# UNITED STATES PATENT AND TRADEMARK OFFICE

10/578,702

<b>Office Action Summary</b>	<b>Application No.</b> 10/578,702	<b>Applicant(s)</b> MEIER ET AL.	
	<b>Examiner</b> Erica E. Cadugan	<b>Art Unit</b> 3726

## DETAILED ACTION

**FIG. 2**

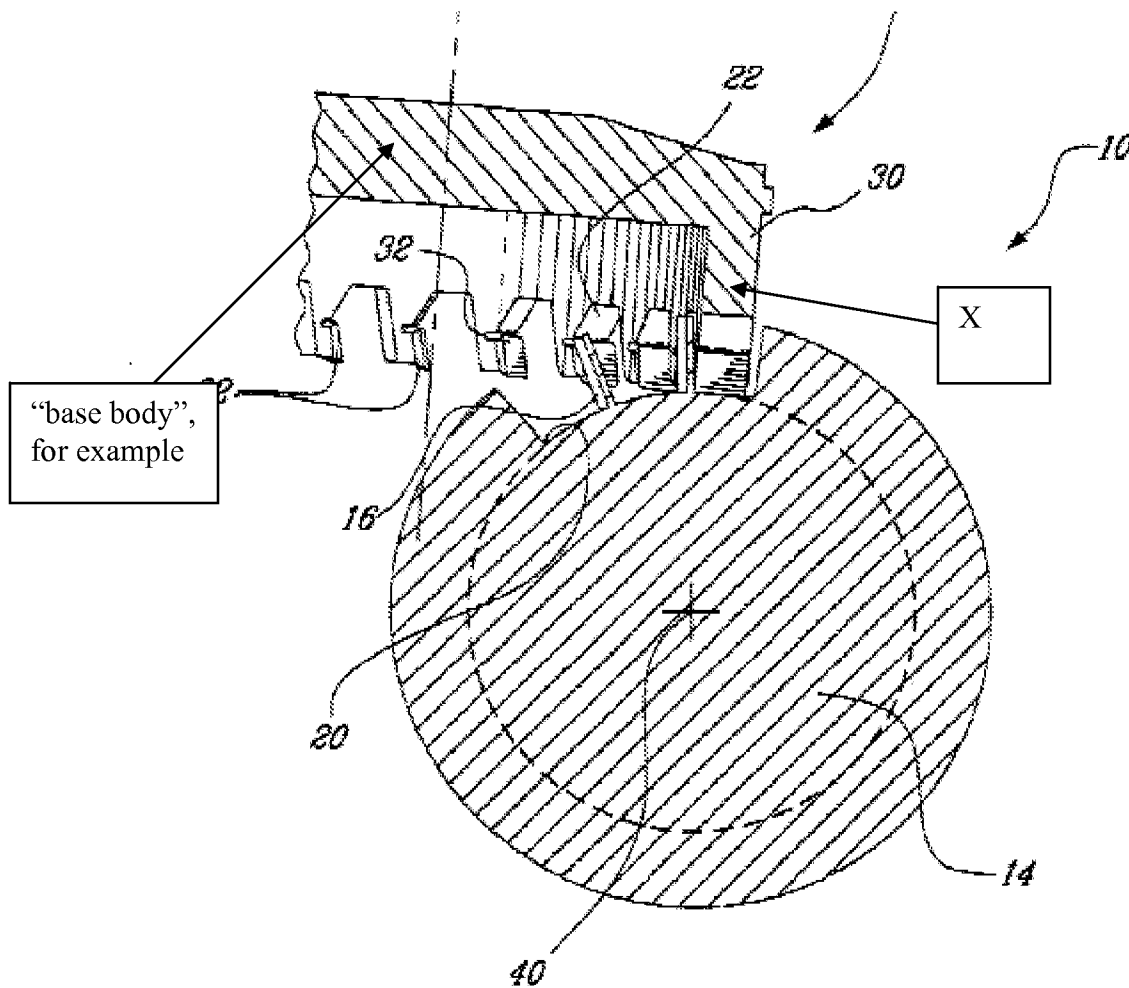
Sasu teaches a method for milling recesses (between airfoil blades 12) of a “gas turbine component” (re claim 31; see Figures 1-3 and at least col. 1, lines 5-9, for example). The method uses a milling tool 28 having a disk-shaped or plate-shaped “base body” (labeled below in the partial reproduction of Figure 2) and at least one cutting body (such as either cutting inserts 32, or the combination of cutting inserts 32 with their respective elements “X” as labeled below) that is located on an outer periphery of the “base body”, and which is “angled in relation to” the “base body” (see Figure 2).

Re claim 28 as best understood, note that the “angle” of the “cutting body” described previously appears to “correspond approximately” to an angle between an “outside” surface of the “cutting body” and a (generally horizontal, for example, as viewed in Figure 2) disk-shaped or plate-shaped surface of the “base body” (see Figure 2, for example).

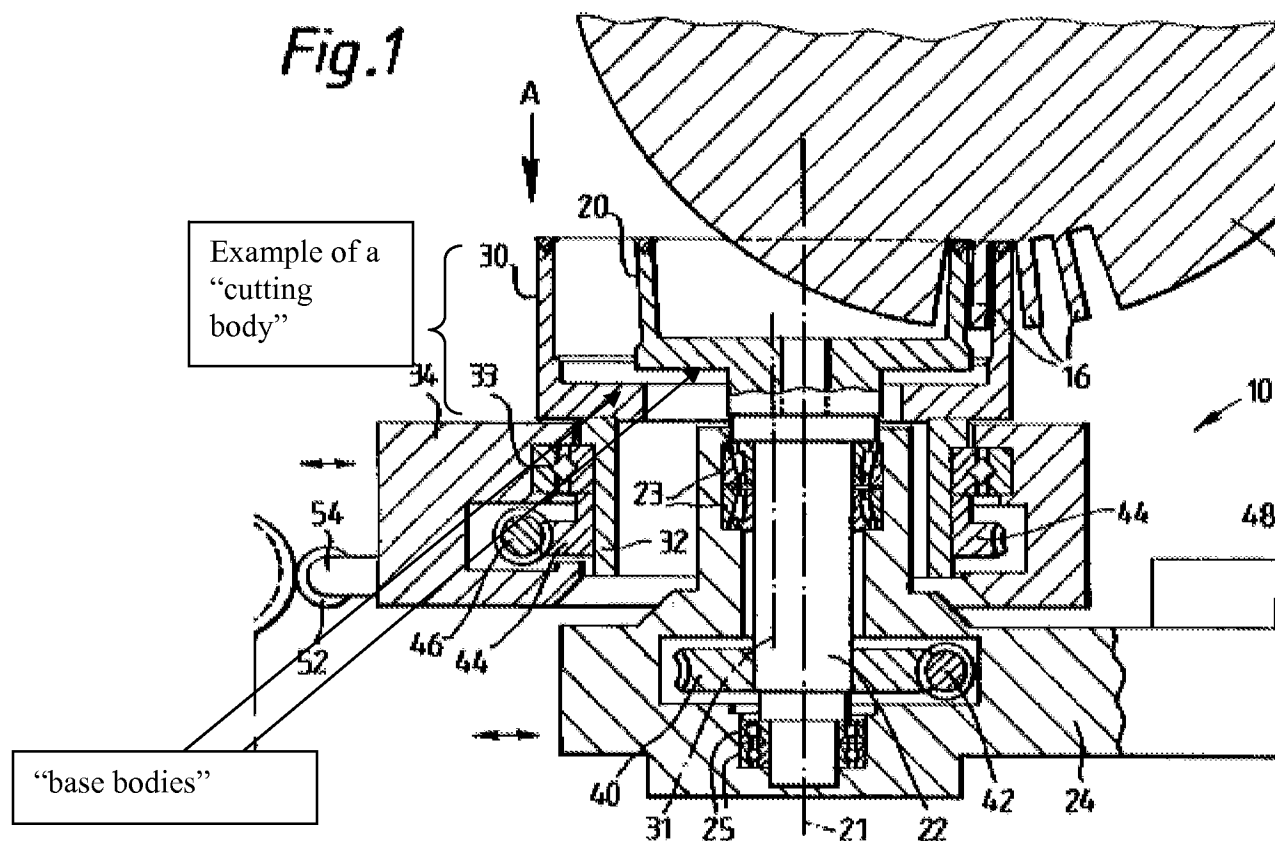
milling tool, such as either 20 or 30, for example (see Figure 1) including a plate-shaped or disk-shaped “base body” (see labeled reproduction of a portion of Figure 1 below).

Note that either the legs shown extending vertically from the “base bodies” in combination with the cutting inserts at the ends thereof (the combination labeled above as “Example of a cutting body”) can be considered a “cutting body” located on an outer periphery of the “base body”. Alternatively, the cutting inserts alone can be considered to constitute “cutting bodies” as claimed.

In either case, note that the “cutting bodies” are “angled” in relation to the base bodies labeled above (see Figure 1).

Re claim 28 as best understood, note that the “angle” of the “cutting body” described previously appears to “correspond approximately” to an angle between an “outside” surface of the “cutting body” and a (horizontal, for example, as viewed in Figure 1) disk-shaped or plate-shaped surface of the “base body” (see Figure 1).
